3 Volt Intel[®] Advanced+ Boot Block Flash Memory

28F800C3, 28F160C3, 28F320C3, 28F640C3

Specification Update

November 2002

2. 28F320C3xC Reset Failure

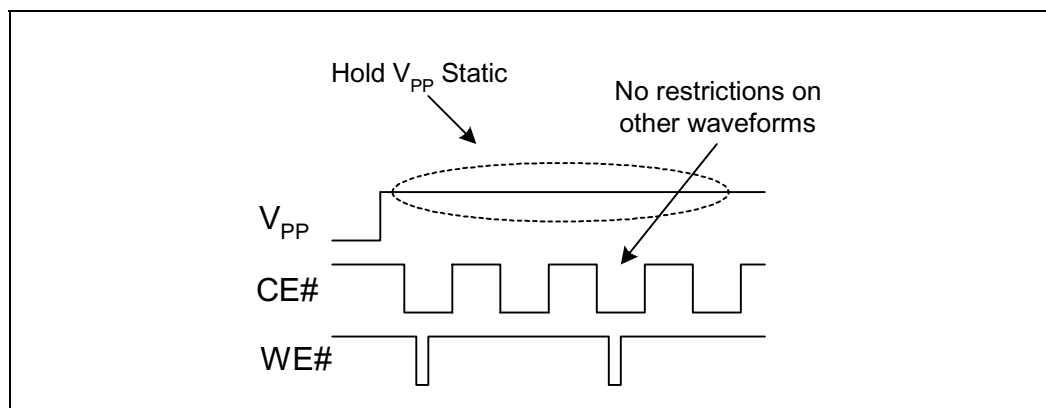
Problem: The 0.18 μm 28F320C3xC devices can unintentionally reset under certain conditions where V_{pp} toggles.

Implication: When the reset occurs, any command being executed is interrupted and the flash switches to read array mode.

Workaround: There are four workarounds for this erratum:

- 1) Tie V_{pp} to V_{CC} ;
- 2) If the third and forth digits on the top side FPO mark (third line) is equal or greater than “23”, then V_{CC} may be set from 2.7v to 3.3v. V_{CC} must not exceed 3.3v
- 3) Set V_{pp} to a static high or static low level as shown here; and

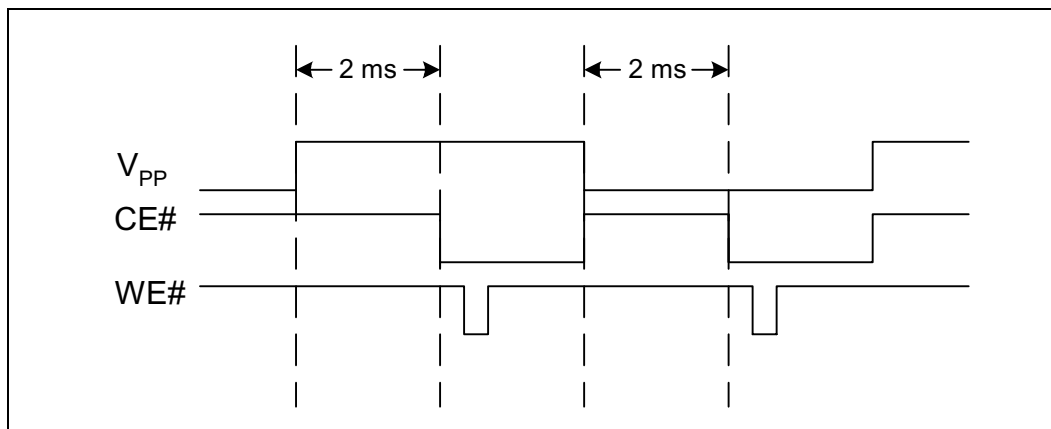
4) Wait 2 ms after a V_{PP} transition to access the flash device, as shown here.

Figure 1. Workaround Placement

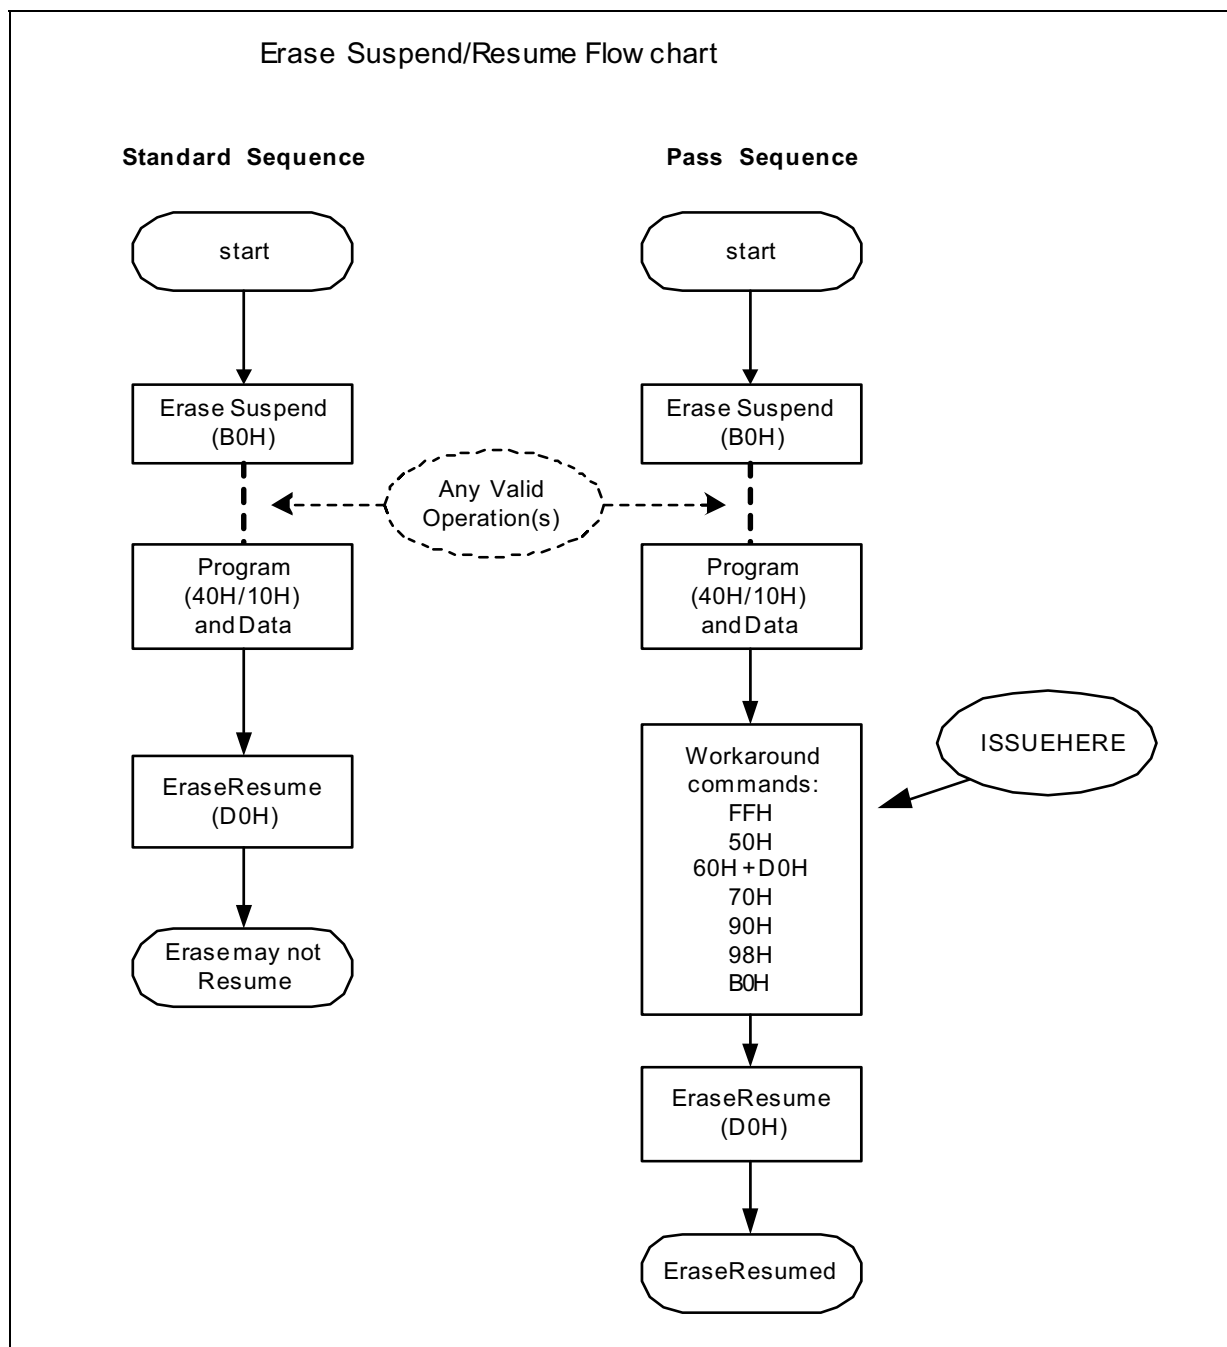
Problem: On the 0.18μm 28F160C3xC devices, a design anomaly was discovered. During an Erase-Suspend operation, if the Program (40H/10H) sequence is executed, under limited conditions the proceeding Erase Resume command (D0H) may not actually resume the device. No customers have reported failures in product applications. Customers who use any version of FDI (Intel Flash Data Integrator) software will not see this issue. If the Read Array command is issued prior to the Erase Resume command, users will not see the issue (typical in XIP applications).

Implication: The Resume Command (D0H) may be ignored by the device and will not correctly resume. The device will appear to remain in suspend (via status register). After a reset of the flash device the status register will clear. This failure has been recreated in a lab environment only.

1. If FDI (Intel Flash Data Integrator) software is used, users will not see the issue.
2. During an Erase-Suspend (B0H), user must issue any of the following commands after issuing the Program (40H/10H) and data sequence but before issuing the Erase-Resume (D0H) command.

5. 28F160C3xC and 28F640C3xC Lock/Unlock/Lock-Down Operation

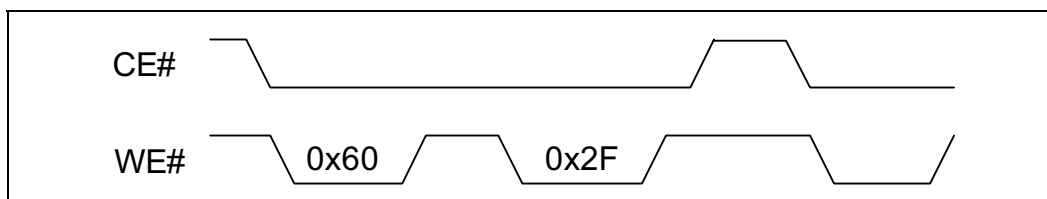
Problem: On the 16Mb and 64Mb 0.18 μ m devices, if CE# is deasserted after any block lock operation and before the next write sequence, the part may perform the same operation on additional blocks. (See waveform below.)

Implication: When CE# is deasserted after performing a block lock operation to a specific block and prior to the next write sequence, other blocks may perform the same operation.

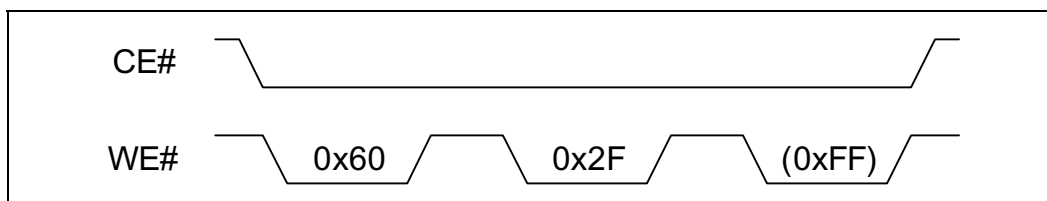
Immediately after performing a block lock, unlock, or lock-down operation, perform a valid write sequence before chip enable (CE#) is deasserted.

For example, one possible solution is shown below:

- 1) Assert CE# and toggle WE# to write the block lock setup command (0x60).
- 2) Toggle WE# a second time to write the confirm command (lock = 0x01; unlock = 0xD0; lock-down = 0x2F).
- 3) Toggle WE# a third time (ex: 0xFF- Read Array) before CE# is deasserted. (See waveform below.) Any other valid write sequence will also work (i.e., 0x90 - Read Configuration, 0x40 - Program, 0x20 - Erase).
